**MEMORANDUM PUBLIC WORKS – COUNCIL MEMO NO. PWE08-017**

**SUBJECT:** ORDINANCE NO. 3932 AMENDING SECTION 43-5.1 OF CHAPTER 43 OF CHANDLER CITY CODE RELATING TO THE CITY OF CHANDLER STANDARD SPECIFICATIONS AND DETAILS

**SUBJECT:**        May 2008 Amendment to the Engineering Standard Details and Specifications (2007 Edition)

**6" RECLAIMED WATER  
IRRIGATION SERVICE LINE  
INLINE PUMP TYPE**

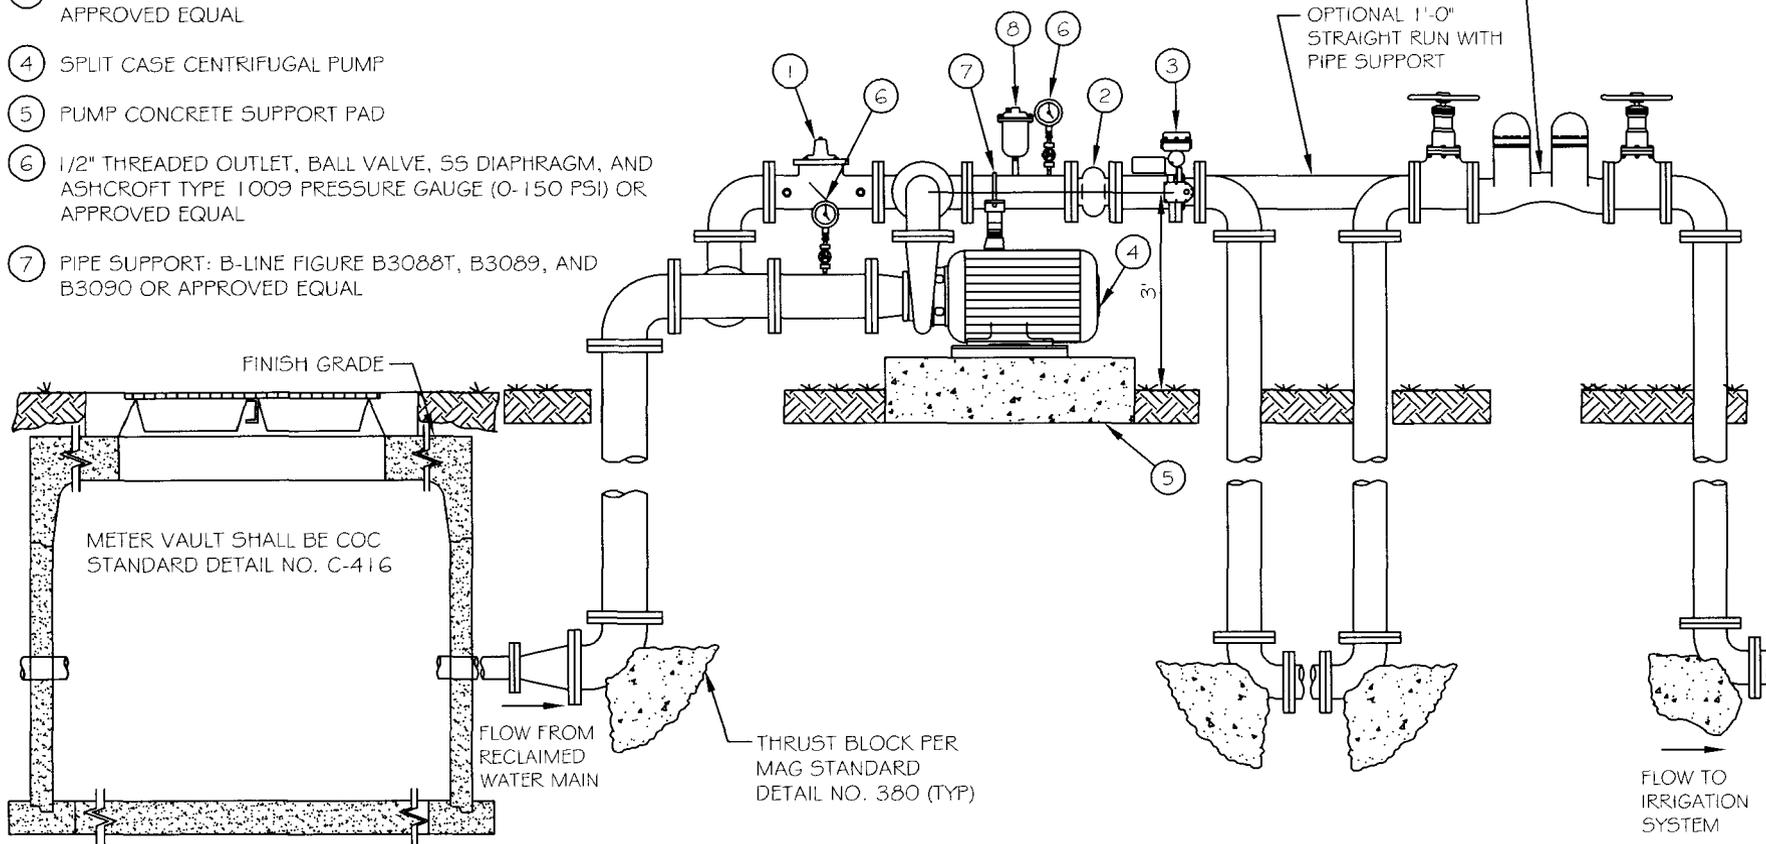
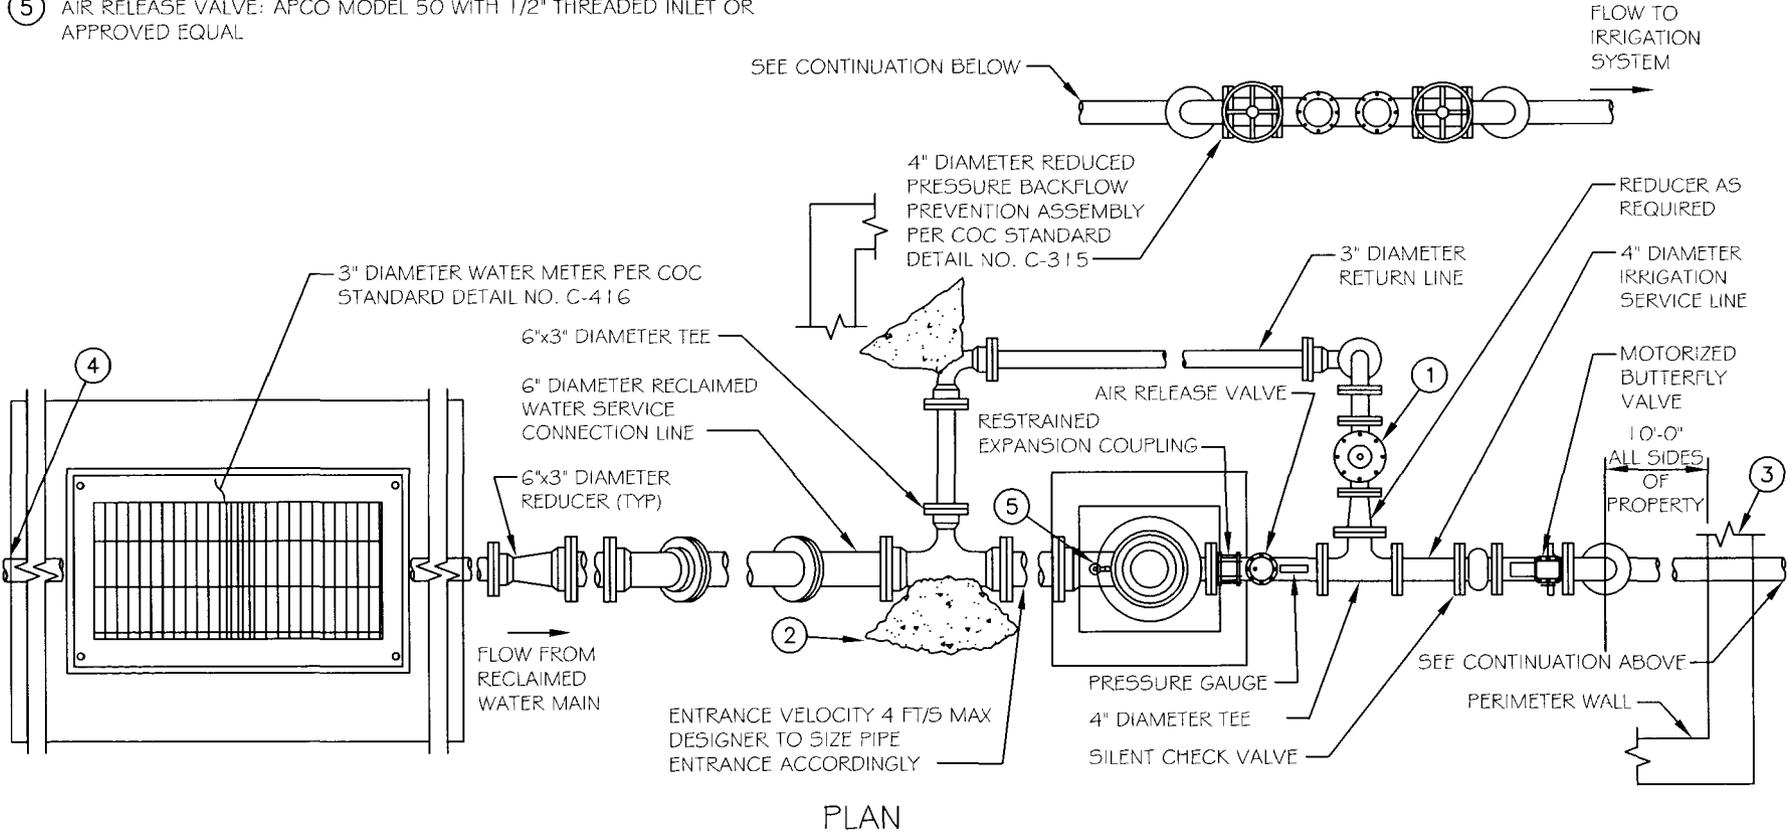
- Detail C-404 (PG 1-12) – revisions and additional standard details needed for reclaimed water services to accommodate various meter sizes and flow requirements.
